Evaluation of a proposal for reliable low-cost grid power with 100% wind, water, and solar

Edited by B. L. Turner, Arizona State University, Tempe, AZ, and approved February 24, 2017 (received for review June 26, 2016)

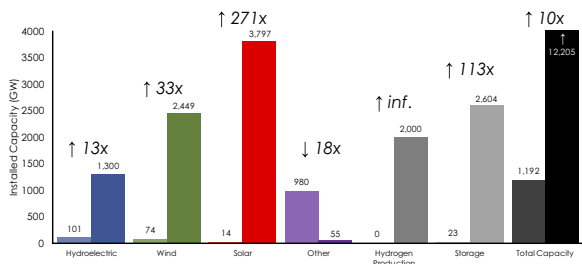
The 100% wind, solar, and hydroelectric power system study (11) also makes unsupported assumptions about widespread adoption of hydrogen as an energy carrier, including the conversion of the aviation and steel industries to hydrogen and the ability to store in hydrogen an amount of energy equivalent to more than 1 month of current US electricity consumption. Furthermore, in figure S6 of ref. 11, hydrogen is being produced at a peak rate consuming nearly 2,000 GW of electricity, nearly twice the current US electricity-generating capacity. As detailed in *SI Appendix*, section S2.3, the costs and feasibility of this transition to a hydrogen economy are not appropriately accounted for by ref. 11. To show the scale of the additional capacities that are demanded in refs. 11 and 12, we plot them along with the electricity generation capacity in 2015 in Fig. 2. The data used for Fig. 2 can be found in *Datasets S1* and *S2*.

Refs. 11 and 12 cite each other about the values of capacity. For example, ref. 12, which supposedly includes information for all 50 states, reports table S2 in ref. 11 as the source of the numbers. Then, ref. 11, which only includes information for the capacity in the 48 contiguous states, cites table 2 in ref. 12 as the source of the values. The values in the two papers do not agree, presumably because of the difference in the number of states included, and therefore, it is unclear how each reference can be the source of the values for the other one. Additionally, ref. 11 assumes that 63% of all energy-intensive industrial demand is

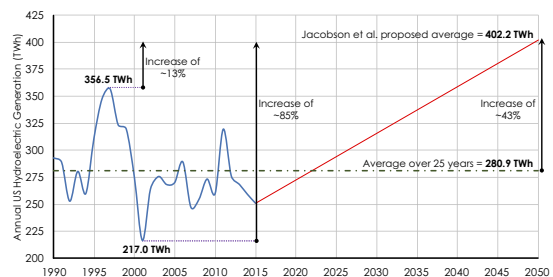
To illustrate the implausibility of the assumed increase in hydroelectric net generation (dispatched from the plants to the electricity grid) in the face of limited water supply, we plot in Fig. 3 the last 25 y of generation from hydropower in the United States along with the average for the studies in refs. 11 and 12. The data used for Fig. 3 can be found in *Datasets S1* and *S2*. Average future generation assumed by refs. 11 and 12 is 13% higher than the highest peak year in the last 25 y and 85% higher than the minimum year in the last 25 y. Therefore, in addition to needing 1,300 GW of peak power from 150 GW of capacity, there also needs to be an extra 120 TWh of hydroelectric gener-

ation on top of the 280 TWh available. Additional difficulties in raising hydropower capacity factors are described in *SI Appendix, section S2.5*.

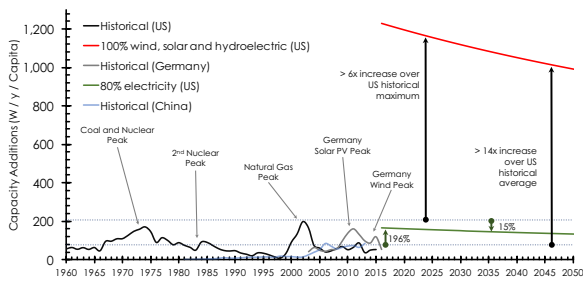
In Fig. 4, we display another metric on the scale of expansion. It shows the rate of installation as watts per year per capita. Using this metric, we can compare the scale of capacity expansion in ref. 11 with historical data. Fig. 4 shows that the plans proposed in refs. 11 and 12 would require a sustained installation rate that is over 14 times the US average over the last 55 y and over 6 times the peak rate. For the sake of comparison, Fig. 4 includes the estimated rate for a solution that decarbonizes the US electric grid by 78% by 2030 (1), historical German data, and historical Chinese data. We note that ref. 1 considered large-scale storage but excluded it based on preliminary results showing that it was not cost-effective compared with a national transmission system. The data used for Fig. 4 can be found in *Datasets S1* and *S2*. Sustaining public support for this scale of investment (and this scale of deployment of new wind turbines, power lines, etc.) could prove challenging. One of the reasons that this buildout may prove difficult is that the 100%
